Access Compliance Report Public Rights-of-Way (Curb Ramps)

Main Street: BRYCE_PL Cross Street: RUSHMORE_LN Location: NE

ADA ID: RPAT211007143810 Ramp Type: Type 1 - Perpendicular Diagonal Initial Pass/Fail: Fail Overall Compliance: No Severity Score: 2

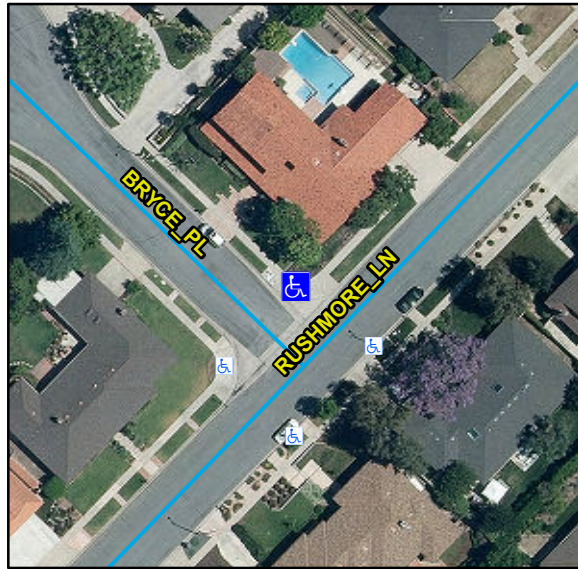
Compliance	Description	Data	Compliance	Description	Data
N/A	Ramp Length (in)	113	N/A	Flare Type LT	
Yes	Ramp Width (in)	64			N/A
Yes	Ramp Run Slope (%)	5.9	N/A	Flare Slope LT (%)	N/A
No	Ramp Cross Slope (%)	2.8	N/A	Flare Traversable LT	N/A
N/A	Landing Present	N/A	N/A	Flare Type RT	
N/A	Landing Length (in)	N/A			N/A
N/A	Landing Width (in)	N/A	N/A	Flare Slope RT (%)	N/A
N/A	Landing Run Slope (%)	N/A	N/A	Flare Traversable RT	N/A
N/A	Landing Cross Slope (%)	N/A	N/A	DWS Provided	N/A
N/A	Landing Movement Obstructed?	N/A	N/A	DWS Contrast	N/A
	Landing Movement Type	N/A	N/A	DWS Length (in)	N/A
N/A	Landing Shared	N/A	N/A	DWS Full Width	N/A
N/A	Clear Space	Yes	N/A	DWS Offset Left (in)	N/A
N/A	Clear Space To Crosswalk (in)	N/A	N/A	DWS Offset Right (in)	N/A
N/A	Marked Crosswalk 1	No	N/A	Marked Crosswalk 2	No
	Crossing 1 Direction	W		Crossing 2 Direction	S
	Marked Crosswalk 1 Width (in)	N/A		Marked Crosswalk 2 Width (in)	N/A

Remove & Replace Curb Ramp With Two New Directional Ramps or Equivalent.
